Topical Report Amendment 21

Pages 17-15 and 17-21

Marked Copy Showing Proposed Changes

Proposed Pages Pages 17-15 and 17-21

Figure 17-3. Off-Site Organization

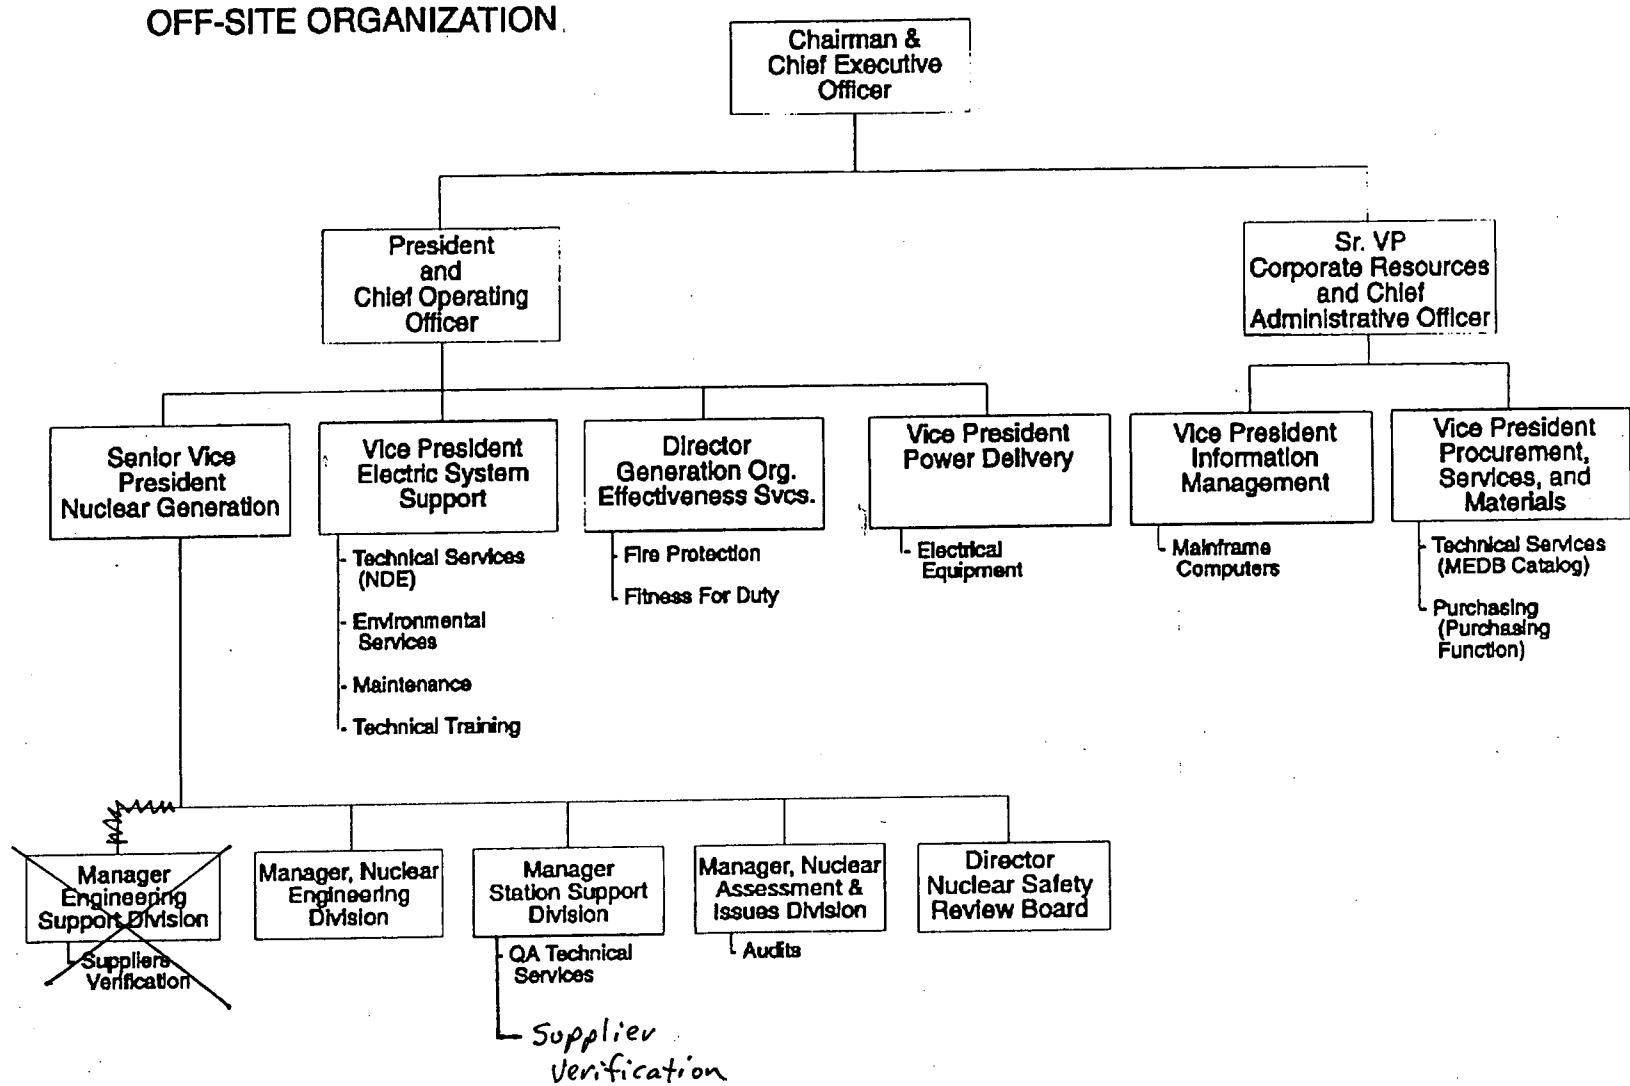
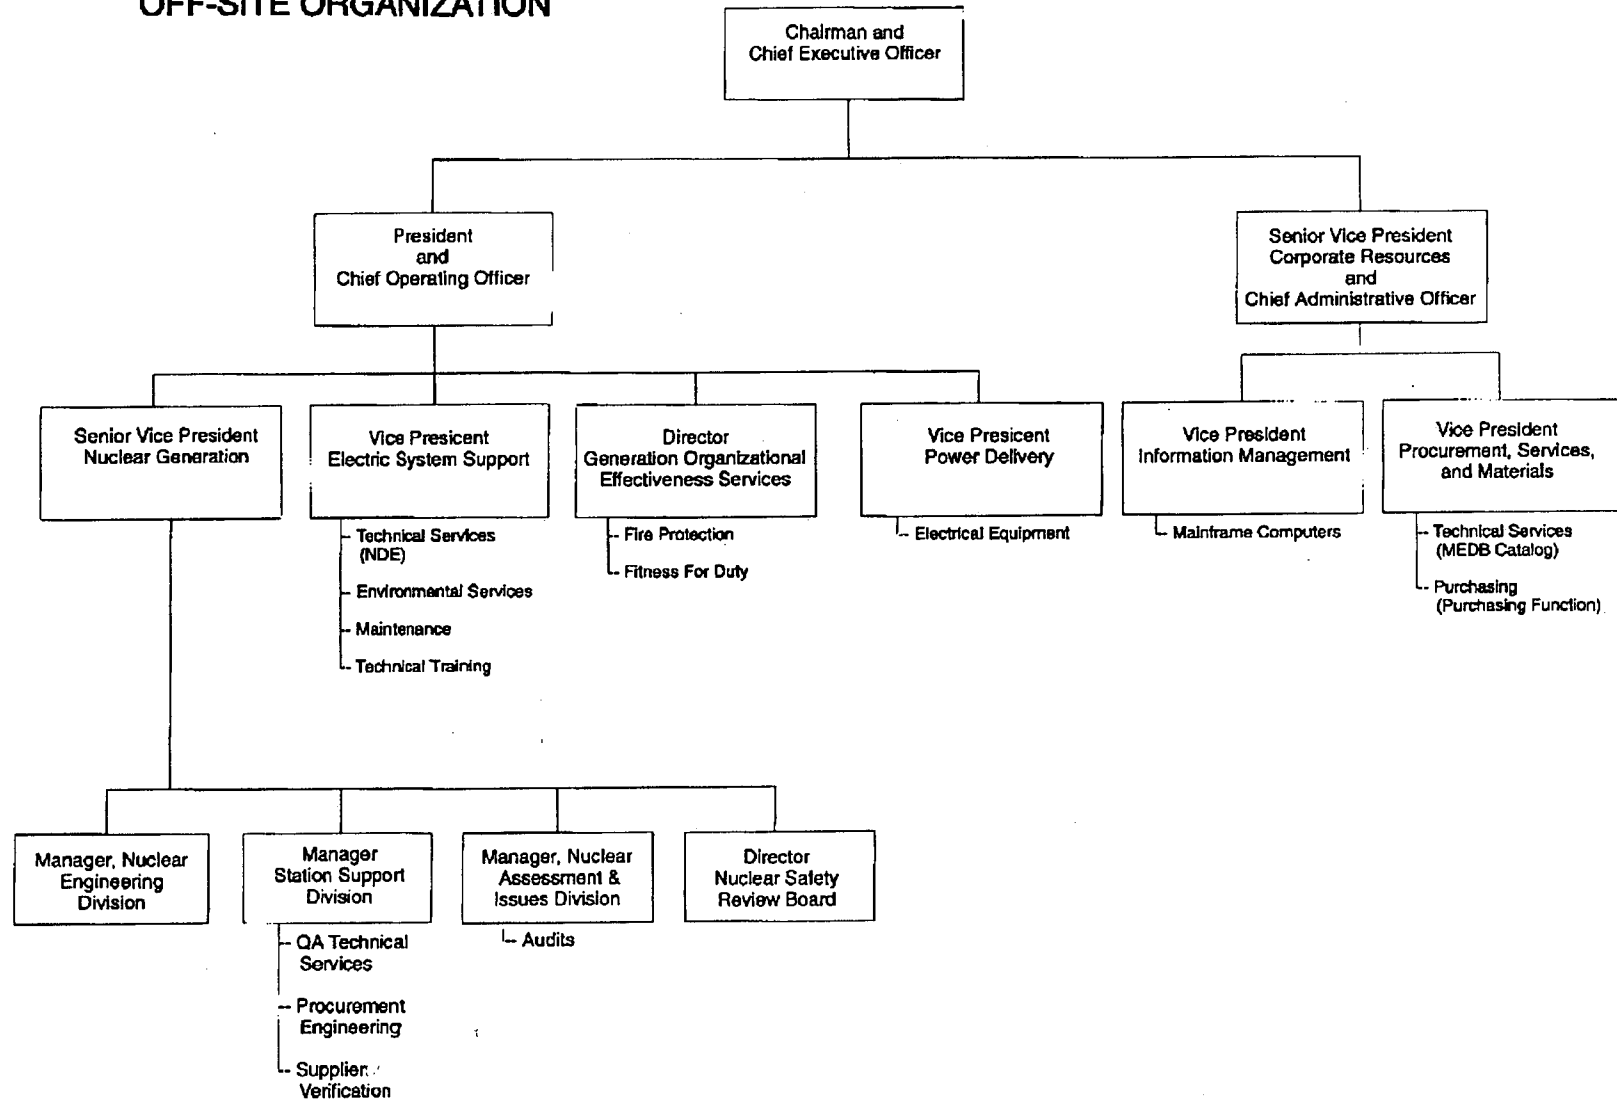
The Nuclear Generation Department, Nuclear General Office, is divided into ~~four~~<sup>three</sup> divisions. The activities of each division are directed by a manager who reports to the Senior Vice President, Nuclear Generation. The divisions within the Nuclear General Office are: ~~(1) Engineering Support, which provides technical support to the stations in procurement, supplier verification, maintenance and engineering;~~ (2)<sup>1</sup> Nuclear Engineering, which provides support to the stations in severe accident analysis, safety analysis, nuclear design, ~~and~~ fuels/core management; (3)<sup>2</sup> Station Support, which provides technical support to the stations in work control and human performance, chemistry, radiation protection, steam generator maintenance, quality assurance services, inservice inspection and special projects such as license renewal, RM&C, and steam generator replacement; and (4)<sup>3</sup> Nuclear Assessment and Issues, which provides technical and business support to the stations in operating experience assessment, operations assessment, business/financial support, regulatory/industry affairs, NSRB,

The Nuclear Generation Department, Nuclear General Office, is divided into three divisions. The activities of each division are directed by a manager who reports to the Senior Vice President, Nuclear Generation. The divisions within the Nuclear General Office are: 1) Nuclear Engineering, which provides support to the stations in severe accident analysis, safety analysis, nuclear design, fuels/core management, procurement engineering, and supplier verification; (2) Station Support, which provides technical support to the stations in work control and human performance, chemistry, radiation protection, steam generator maintenance, quality assurance services, inservice inspection, maintenance, and engineering, and special projects such as license renewal, RM&C, OAC replacement, and steam generator replacement; and (3) Nuclear Assessment and Issues, which provides technical and business support to the stations in operating experience assessment, operations assessment, business/financial
